Groundwater Application Review Summary Form

Application # G- 19346

TO: Water Rights Section Date 2/26/2025
 FROM: Groundwater Section Joe Kemper
Reviewer's Name
 SUBJECT: Application G- 19364 Supersedes review of NA
Date of Review(s)

A. GENERAL INFORMATION: Applicant's Name: Avion Water Co LLC County: Deschutes

Water-Level Measurements in Nearby Wells

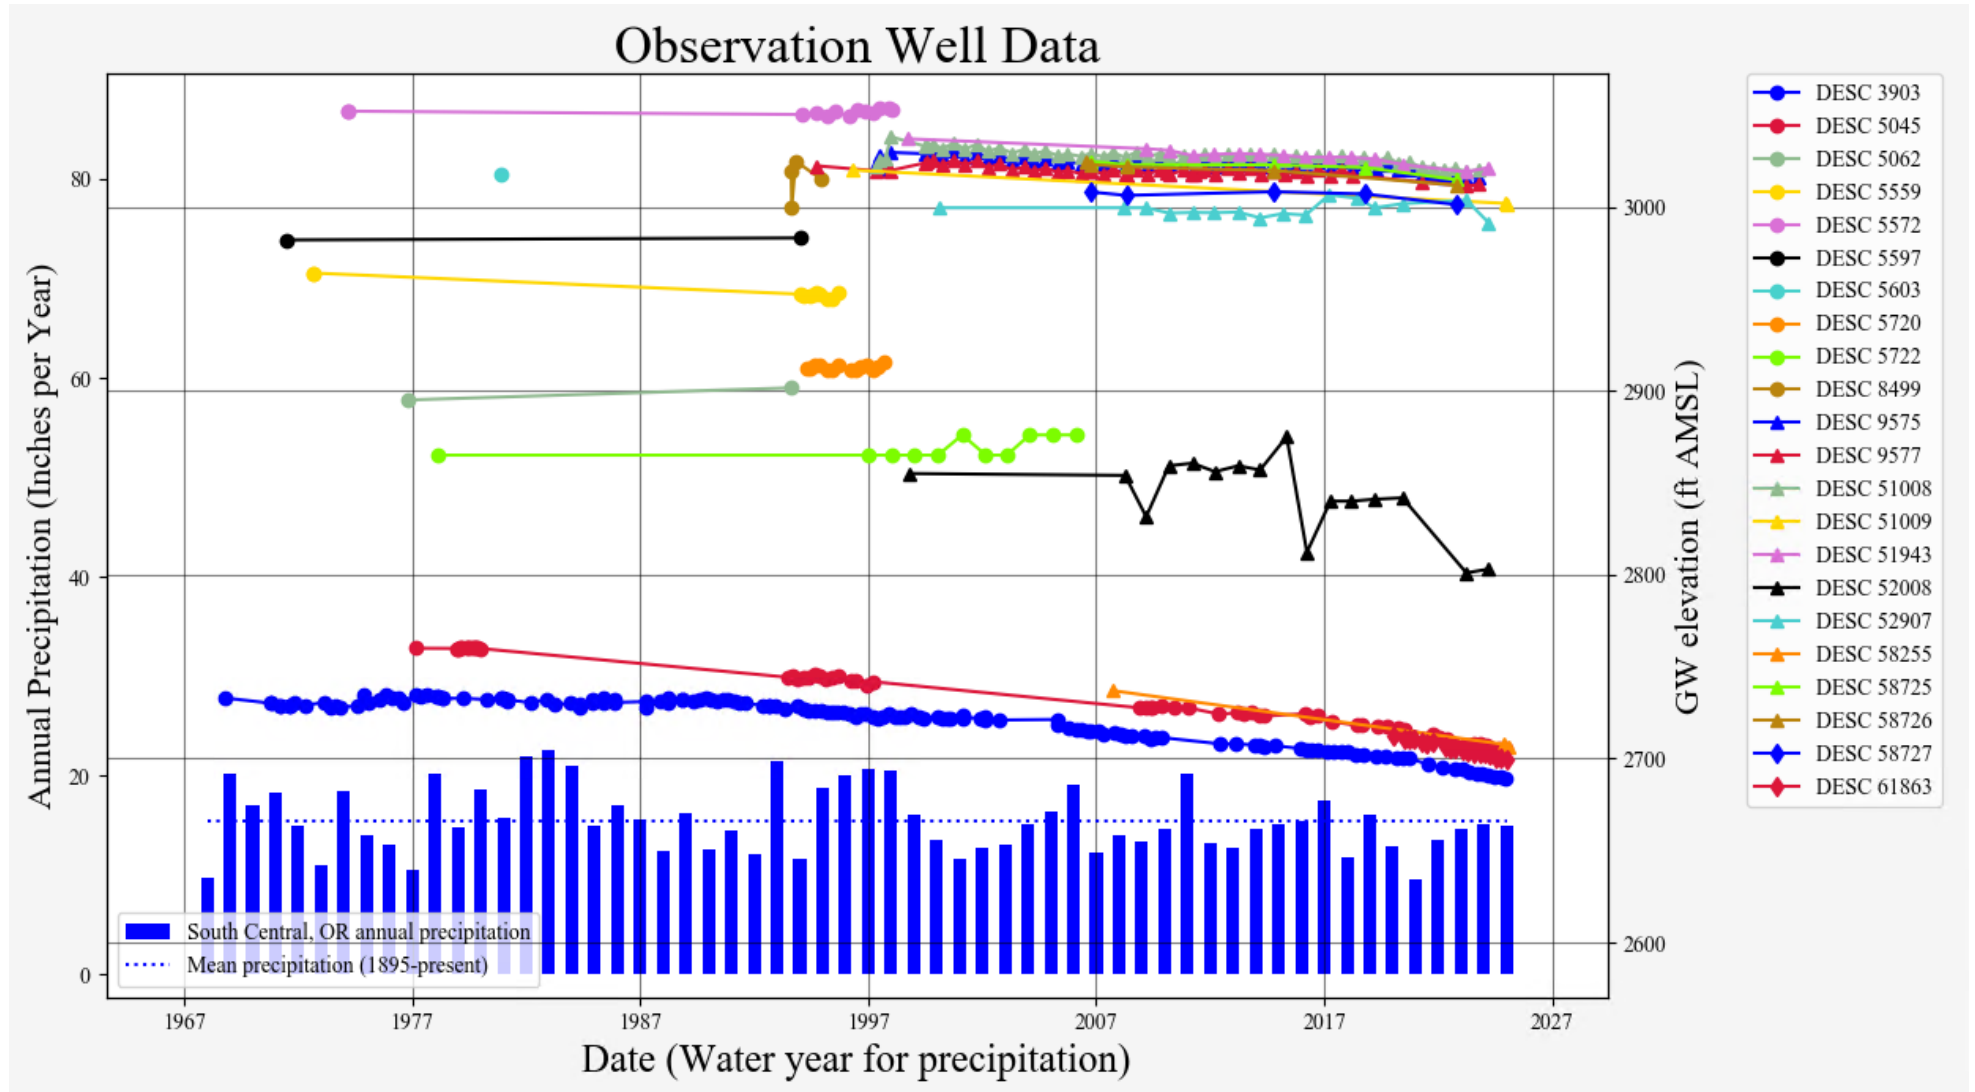
B3. **Groundwater availability remarks:** The applicant’s well (DESC 5603) accesses the Deschutes regional groundwater system hosted within interbedded volcanics of the Deschutes Formation. Wells in the center of the basin between Bend and Redmond have water levels at approximately 2700 feet AMSL that have declined persistently at a rate of ~1 ft/yr since the mid-1990s (e.g., DESC 3903 & DESC 5045 in Hydrograph 1). Those declines have continued through wetter periods of the late 1990s and mid-2000s. Wells closer to the Cascades naturally fluctuate 20-30 feet tracking with 5–10-year climate cycles (e.g., DESC 7260 and DESC 3016 in Hydrograph 3). The applicant’s well has a water level elevation of ~3000 ft amsl and tracks with wells near Pilot Butte (e.g. DESC 51009) and Knott Landfill (e.g. DESC 9577). These wells appear to fall in between the trends seen near the Cascades and in the center of the basin. These wells have declined approximately 15 feet since the mid-1990s but also appear to rebound during wetter periods (see Hydrograph 2). This decline is notable but is less than the 40-50 feet of declines between Bend and Redmond that has raised Capacity of the Resource issues.
